## SKEP III Home Office Support Site Visit Report

Consultant	Wahib Medanat Consultant Engineer	Rep No.	23-05062022
Contractor	Dijlah Establishment Constr. Contracting	Tender No.	(11/2019/USAID/SKEP/3/S) Schools for a Knowledge Economy Project (SKEP) - Phase (3) Package (1, 2)
Site Name	Jumana Bint Abit Taleb Basic Mixed School - Jerash	Day/ Date	Sun. 05/06/2022
Duration of Project	450 Calendar Days	Total Project Budget	8,314,983.735 JD

(Figure: 04)

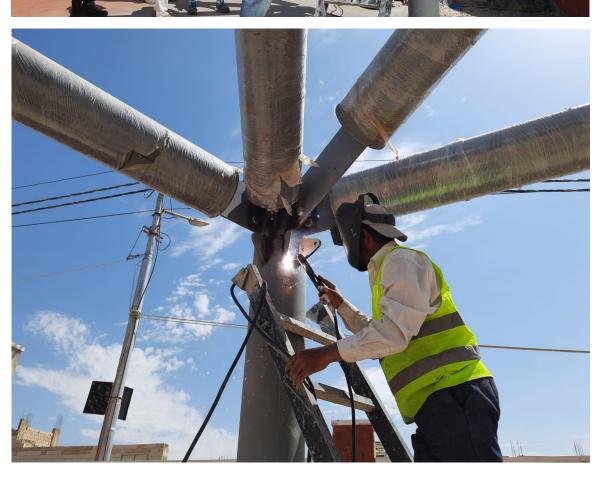
The supervision team observed that the Contractor has removed the defected stones at the facades of the canteen and replaced them by stones that conform to the requirements

(Figure: 14)

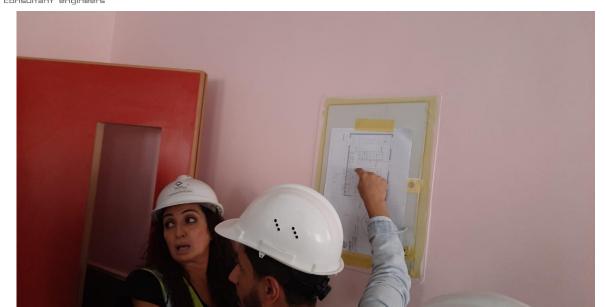
The team observed the delivered laboratory furniture for the vocational laboratory, art room and labs by the manufacturer (Protech)

(Figure: 16)

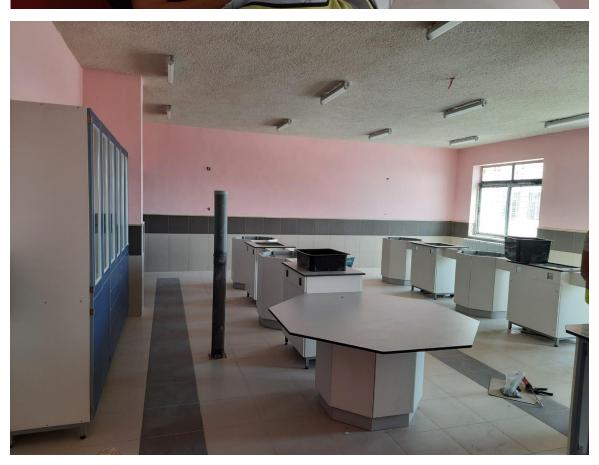
The installation was according to approved shop drawings
